SAN JUAN REGIONAL PLANNING COMMISSION
AGENDA
September 16, 2025
San Juan County Courthouse

Re: Cascade Meadows Subdivision Sketch Plan

Cascade Meadows LLC, 665 Glacier Drive, Unit 5, Durango, CO 81301 has submitted a Subdivision Sketch Plan Application for the development of the Cascade Meadow Subdivision located on Tract A1 and B1.

Sheet Description:
OVERALL GRADING PLAN

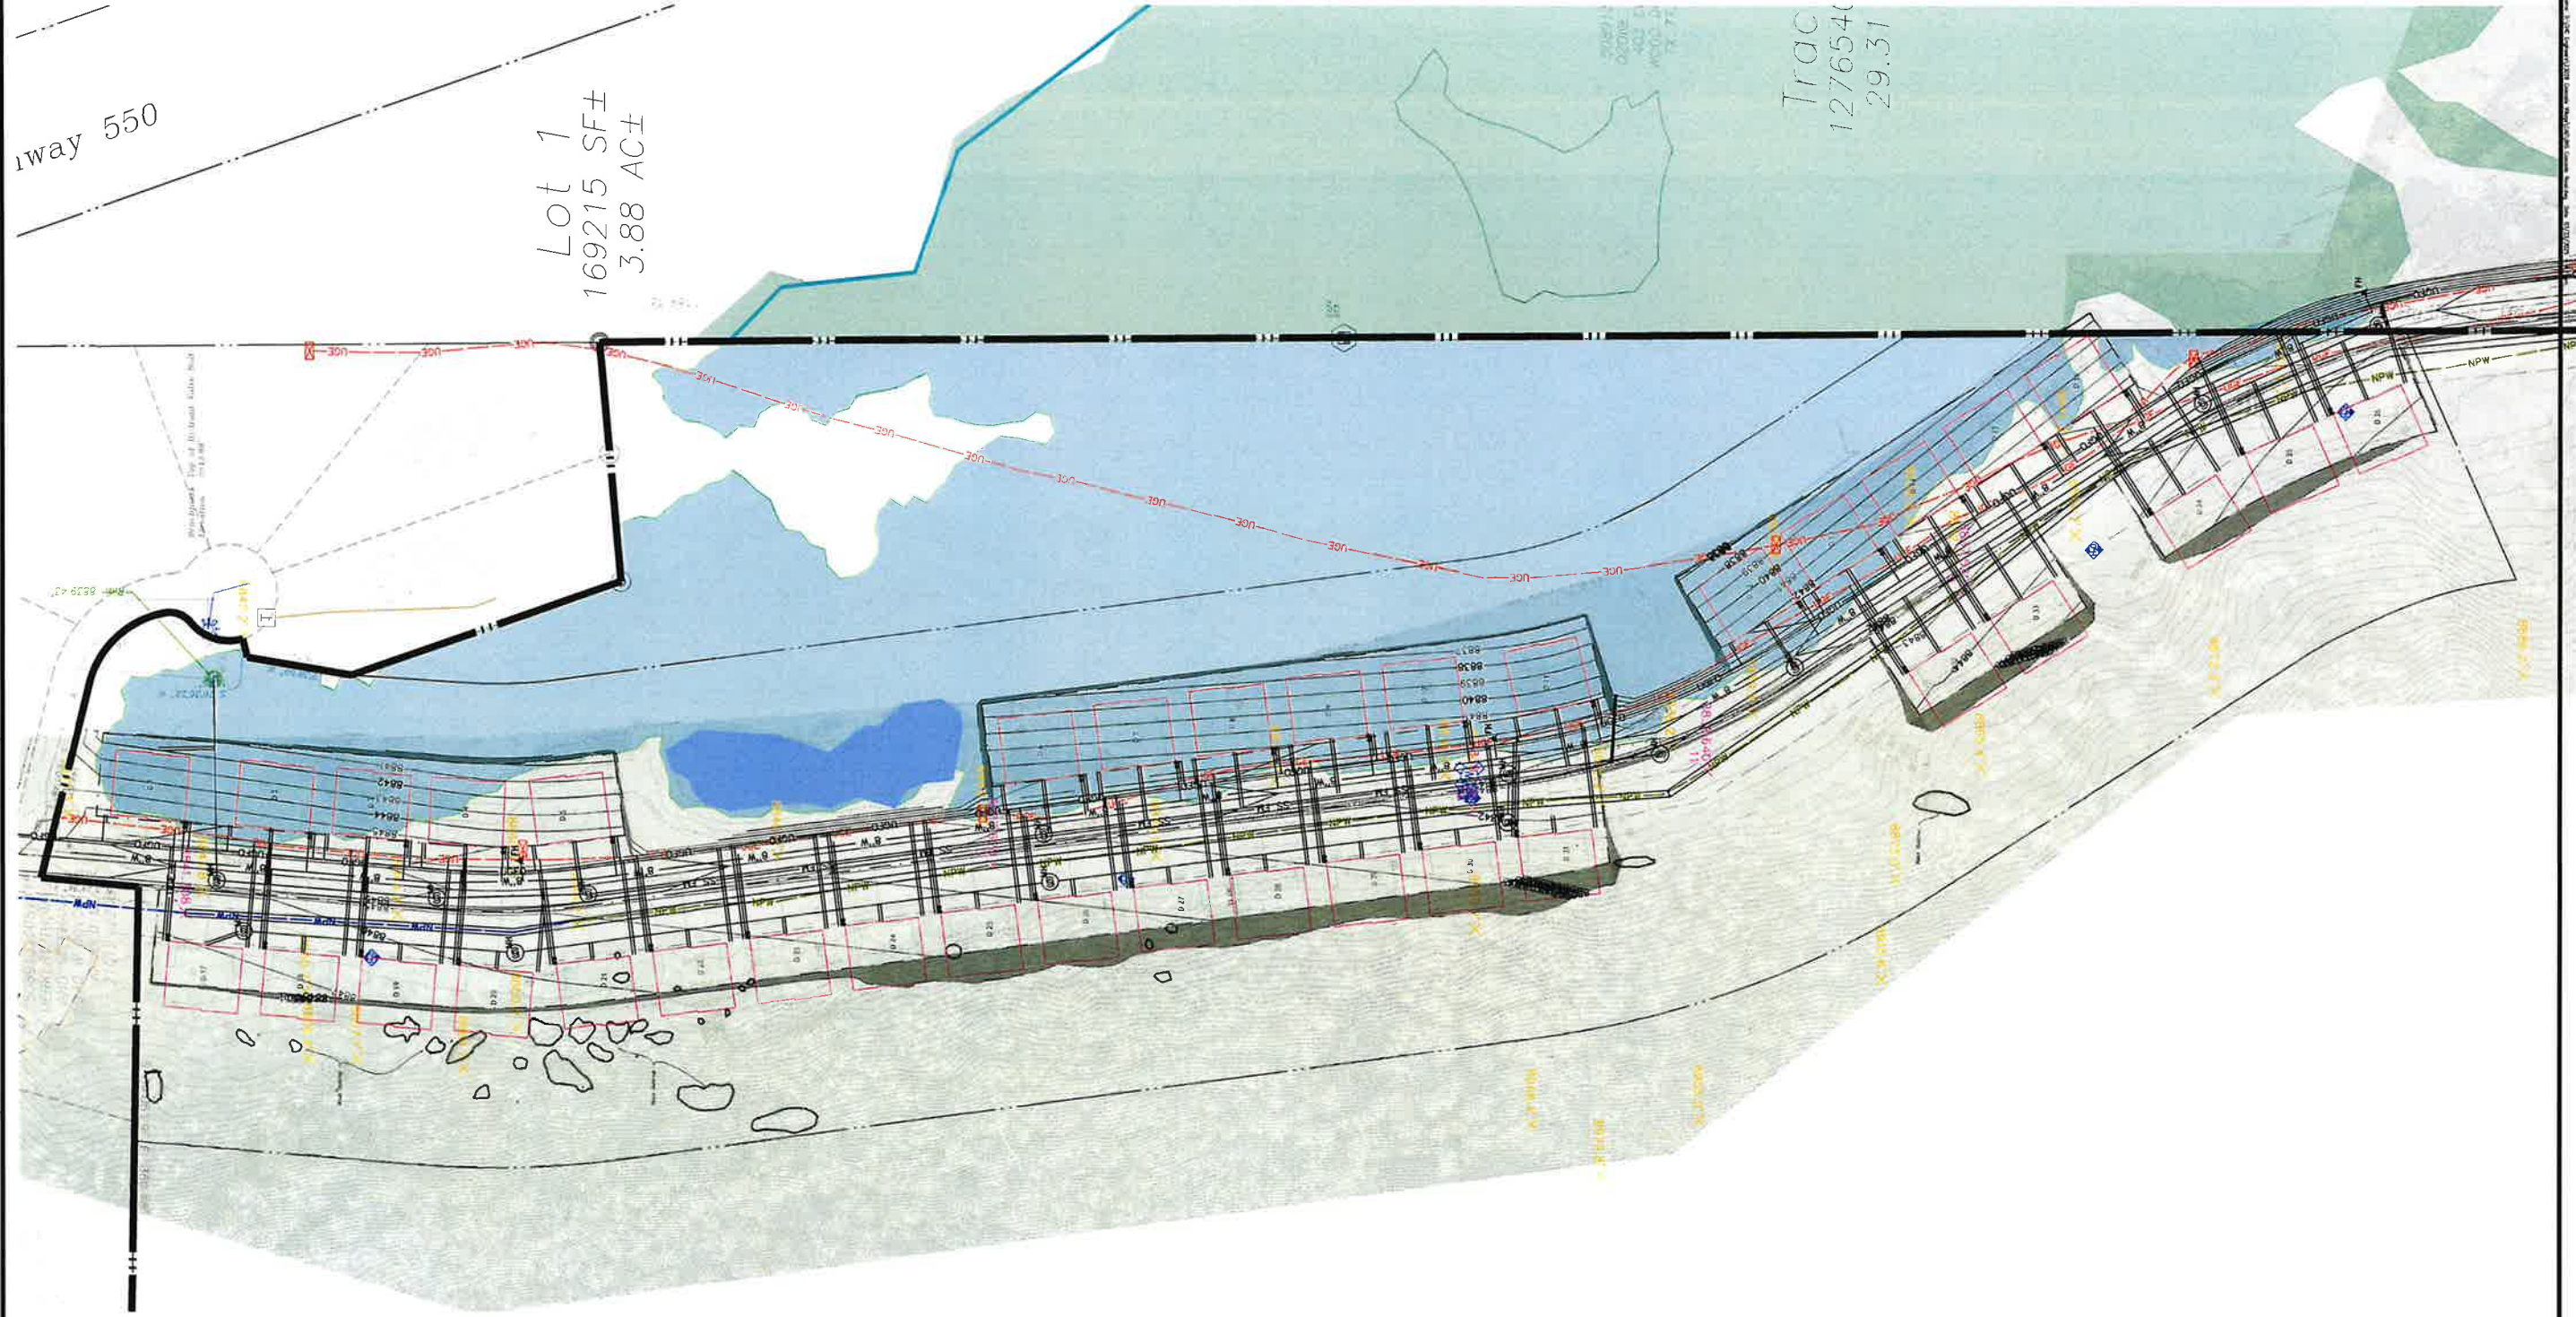
This preliminary development review does not include a complete fire code plan review for construction as the information is limited.

Contact our office as the fire hydrants are installed so we witness the flow tests and verify actual locations of each fire hydrant.

The following conceptual architectural, sectional, and site plans were not reviewed or approved for construction. Should the Building Code Official determine the structure(s) are multi-family units then the structure shall be equipped with a fire suppression system.
